**"8 GeV shielded Hatch"**

To : Tom Pawlak  
CC :Phil Martin  
From: Chandra Bhat  
Subject: 8 GeV shielded Hatch.

8 GeV EQUIPMENT HATCH STEEL SHIELD'G

SUBJECT: 8 GeV Shielded Hatch

STEEL SHIELDING @ S. WALL OF EQUIP HATCH @ CB817

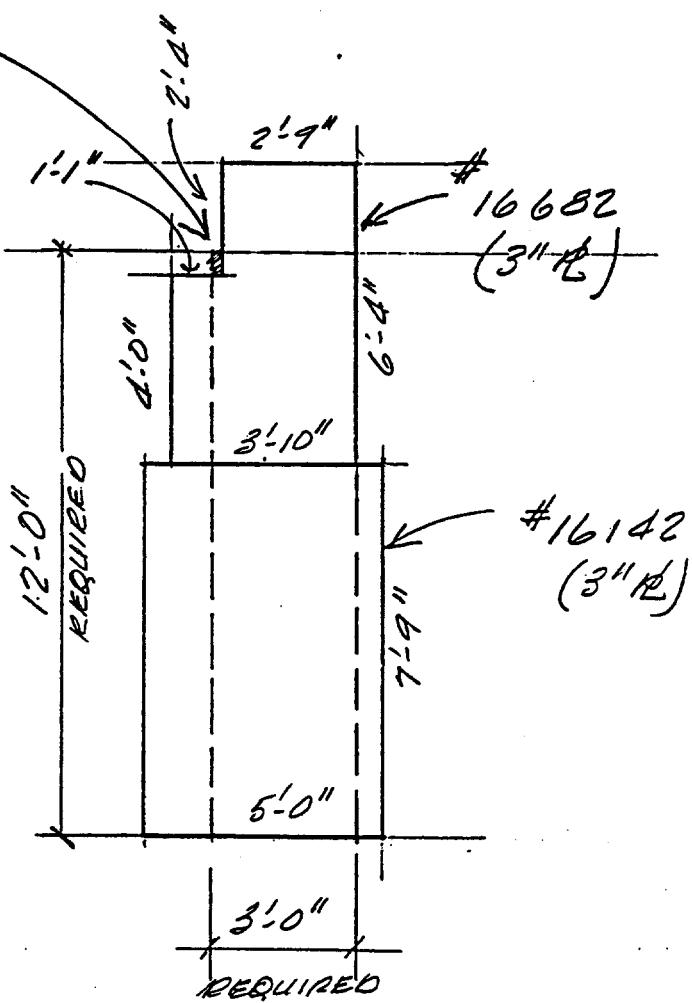
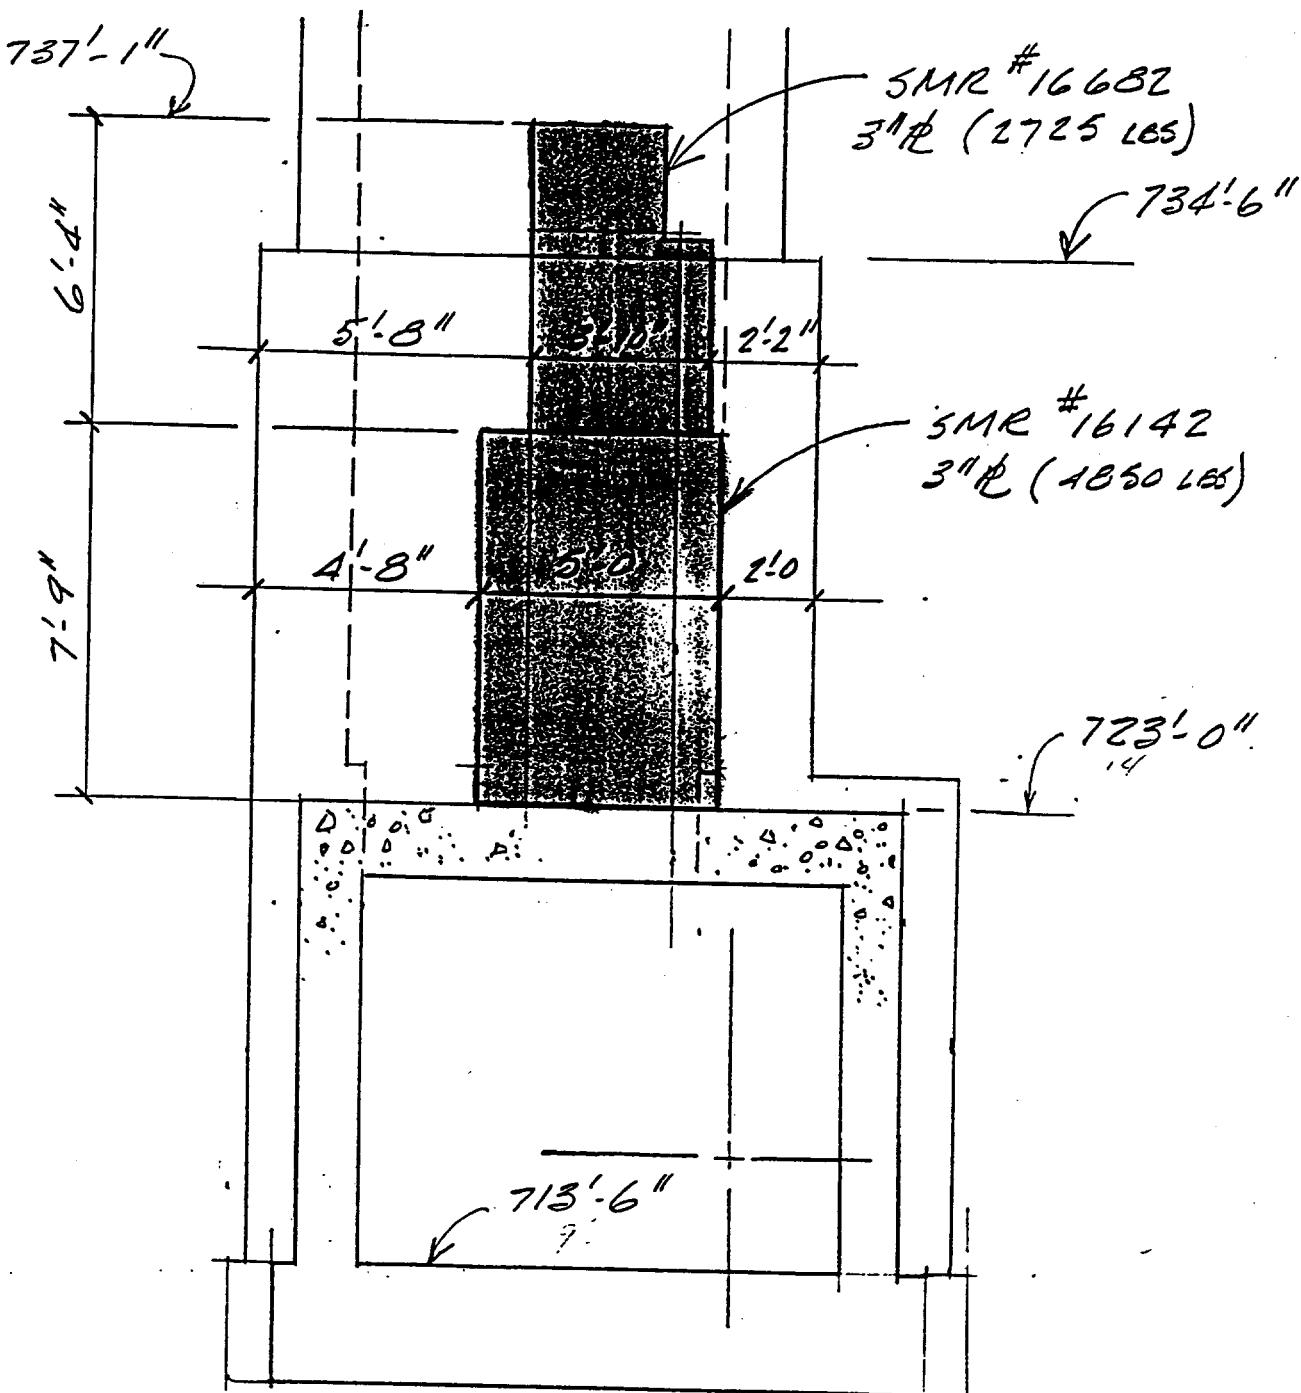
I FOUND 2 STEEL PLATES SLIGHTLY THICKER THAN 3" WHICH ALMOST COVER YOUR 3'X12' REQ'MT AT THE 8 GeV SHIELDED HATCH, WHAT DO YOU THINK?

MISSING AREA  
(3" x 3")

I have looked into the possibility of using the two steel plates ( which you have mentioned in your letter dated 9 Feb., 1996) with thickness slightly over 3" and can be used to cover the 3' X 12' area. I find that the configurations of shielding you have shown in your letter offers enough shielding. The missing area of 3" X 3" is not a problem. If it is not difficult to cut off 2'-4" x 2'-9" piece from " 16682" you can as well cut off it and use somewhere else.

STEEL SHIELDING @ S. WALL OF EQUIP HATCH @ CB017

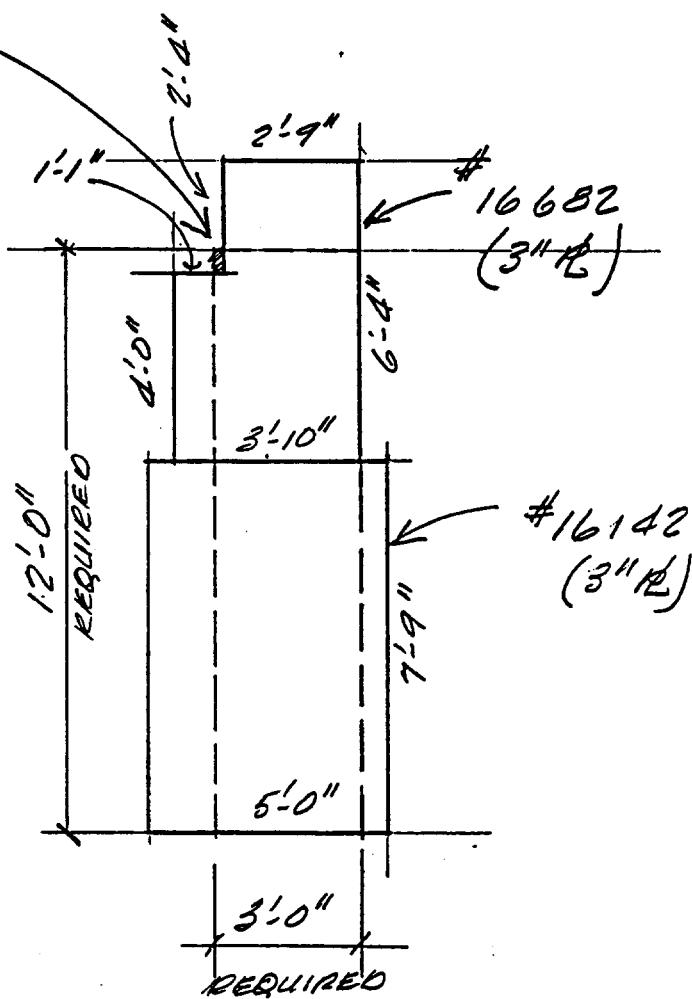
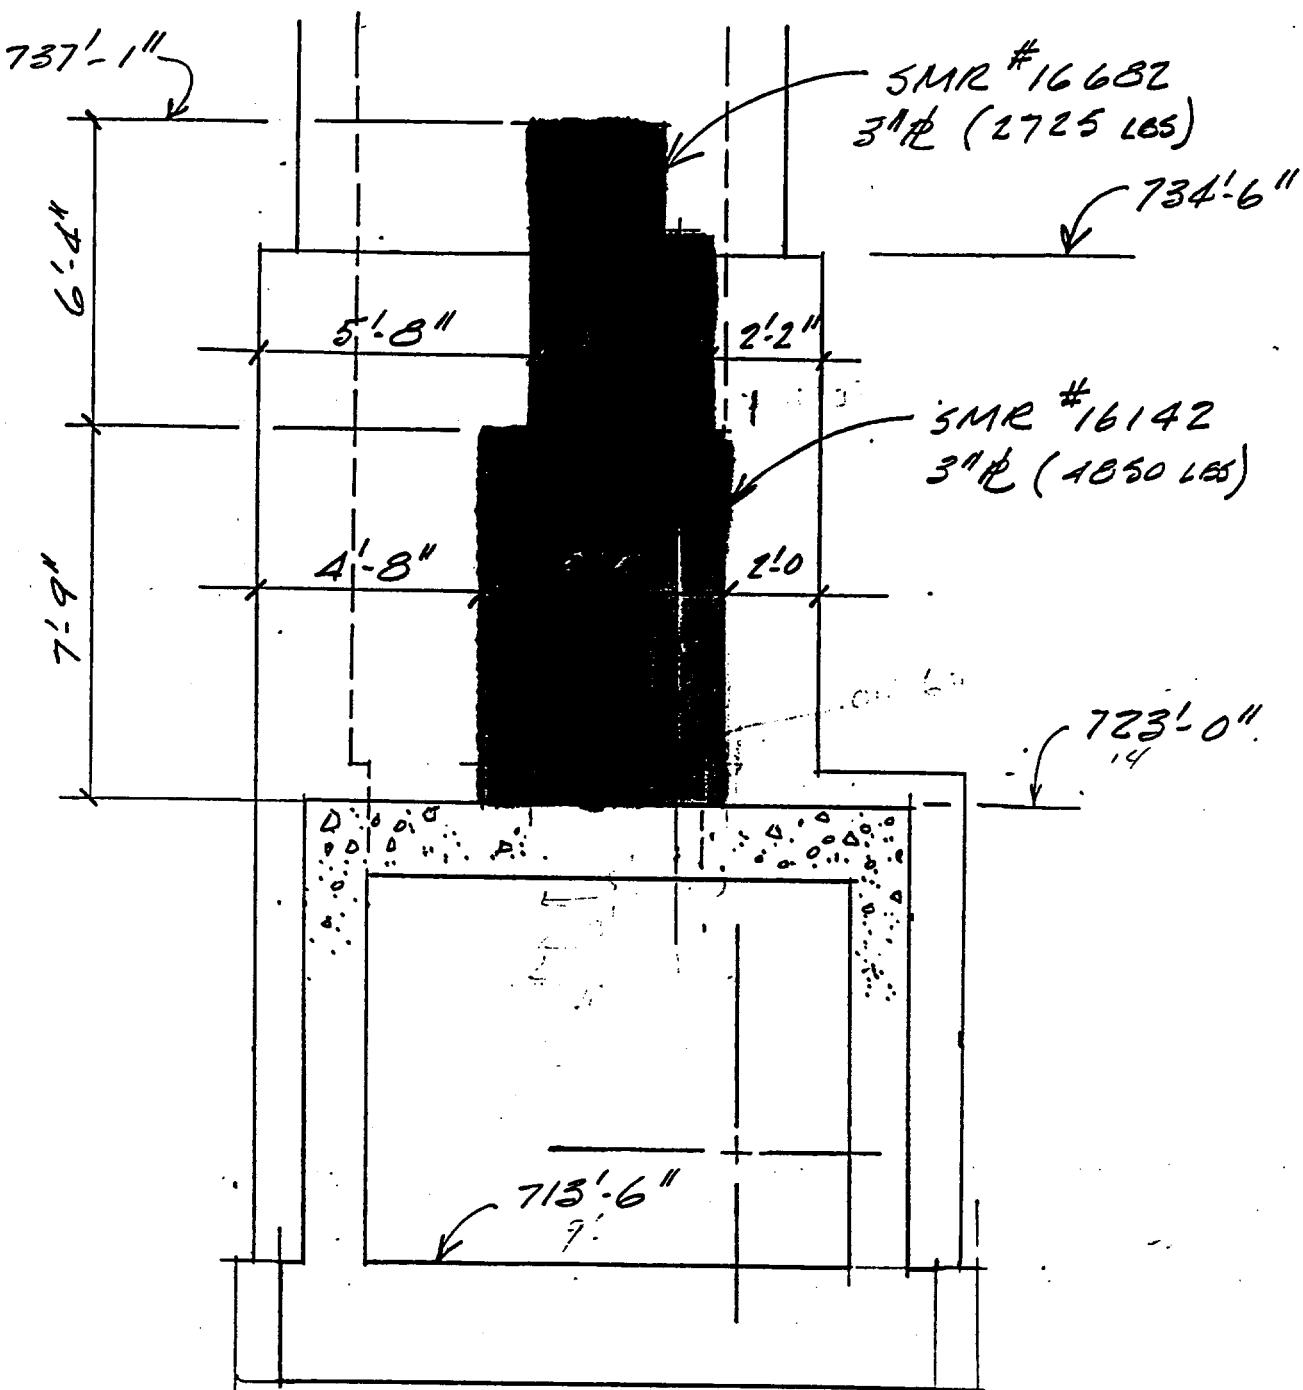
I FOUND 2 STEEL PLATES SLIGHTLY THICKER THAN 3" WHICH ALMOST COVER YOUR 3'X12' REQ'MT AT THE 8 GeV SHIELDED HATCH, WHAT DO YOU THINK?

MISSING AREA  
(3" X 3")

SHIELDED HATCH @ 8GeV ENCLOSURE

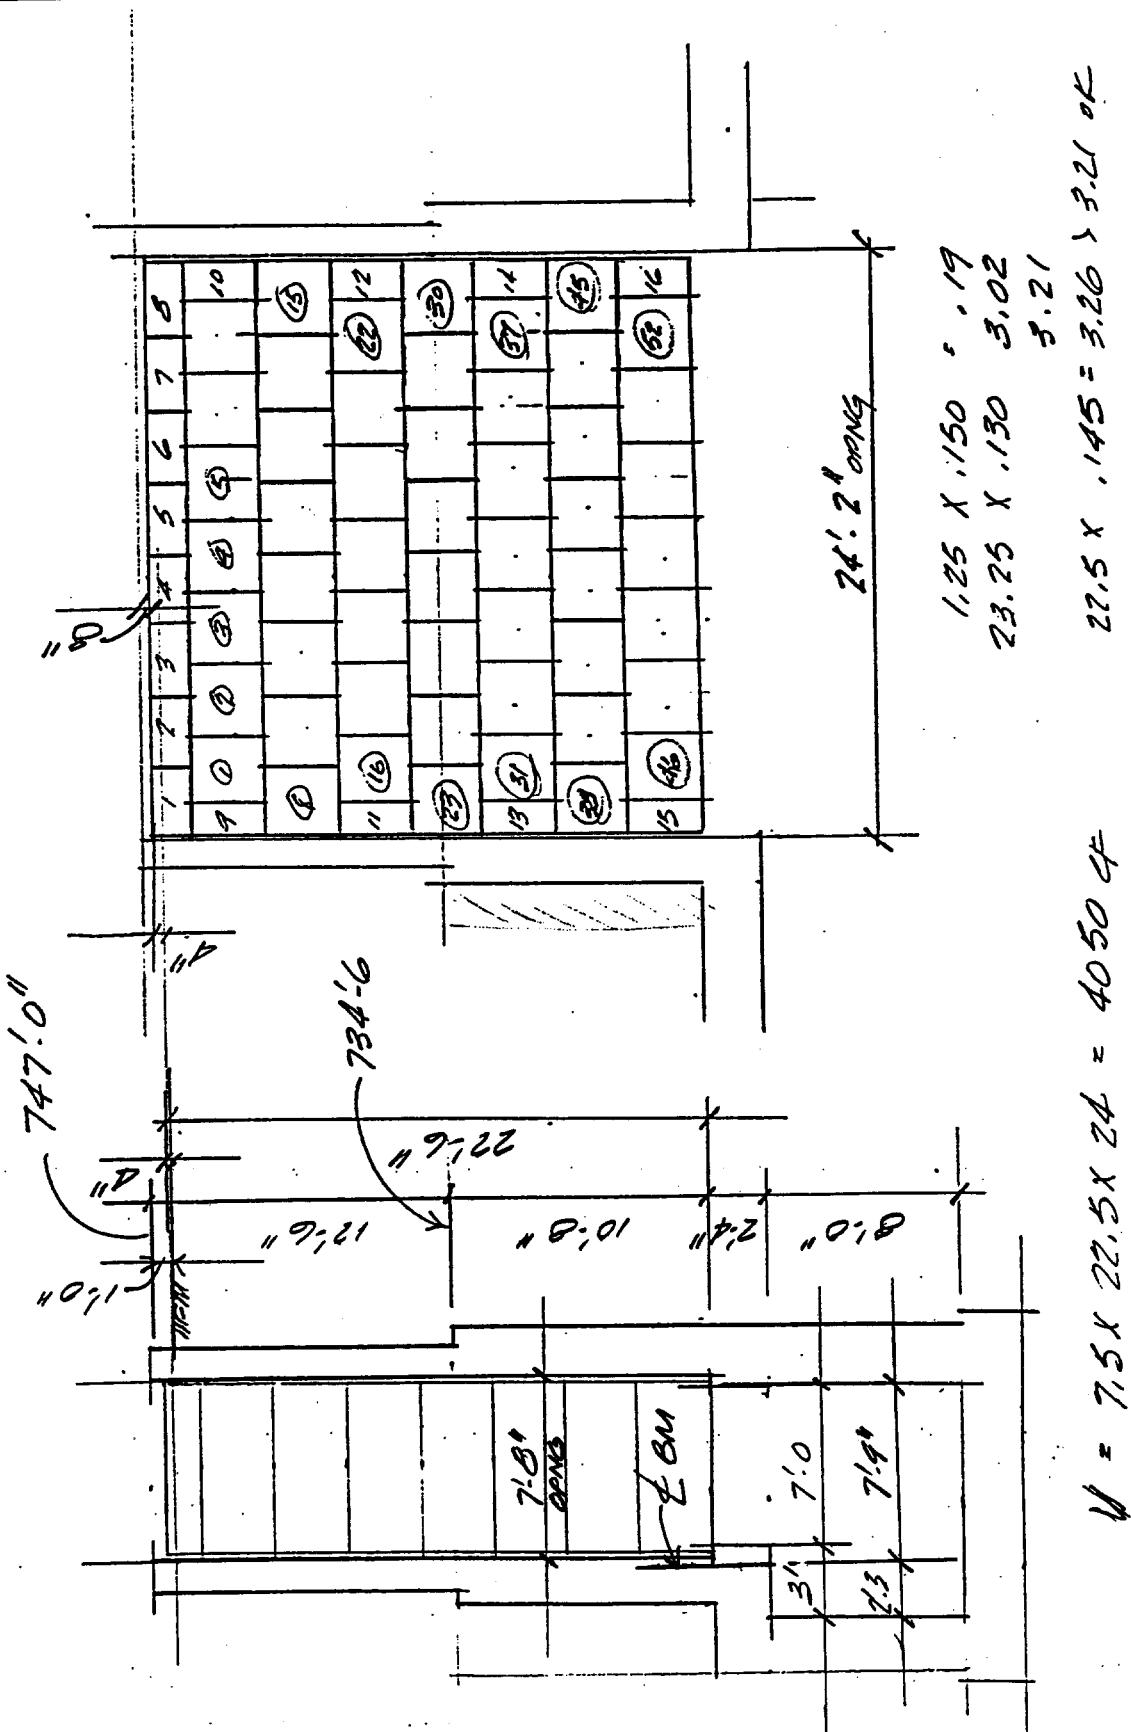
Al Guthke has surplus concrete shielding blocks which I would like to allocate for the subject hatch. However, before I can request a quantity, I need your confirmation of a shielding scheme. The attached sketch proposes a 22'-6" high stack of concrete blocks (which extend 4" above the top of adjacent berm consisting of 16 "A" blocks and 52 "B" blocks. Assuming lightly reinforced concrete weighs 145 p.c.f., the block mass is equivalent to the earth shielding at a typical precast enclosure cross section. Note the beam line is 9" beyond the nominal 7'-0" wide hatch opening. Please let me know how much concrete block shielding is required and what joint pattern you prefer.

I have looked into the Tom Pawlak's proposal for concrete shielding of the 8 GeV shielded hatch with my computer program. With his scheme there will be only 22.5ft of shielding in this region. The dimension of the shielded region is 7.67ft wide X 22.5 ft thick X 24.17ft along the beam direction. As per Fermilab Main Injector Preliminary Safety Analysis Report (dated May 1992), we need a minimum of 24.5 ft thick soil equivalent shielding radially up. Tom has also pointed out that 1) in this region the beam line is about 9 in off the shielded hatch. and 2) the density of the reinforced concrete is about 2.32 gm/cc (i.e., about 1.079 times that of the soil). This certainly helps the shielding. However there is a shielding deficiency up to about 1 ft soil equivalent in certain location towards the down stream end of the hatch. According to my calculations this deficiency in the shielding would give rise to increased radiation level.

I estimate about a factor of 2.2 higher radiation level. This can be reduced to acceptable limit by adding a 12ft X 3 ft X .25 ft steel slab. A figure is attached herewith. Or we may have to display a sign stating 'Caution - Controlled Area'.
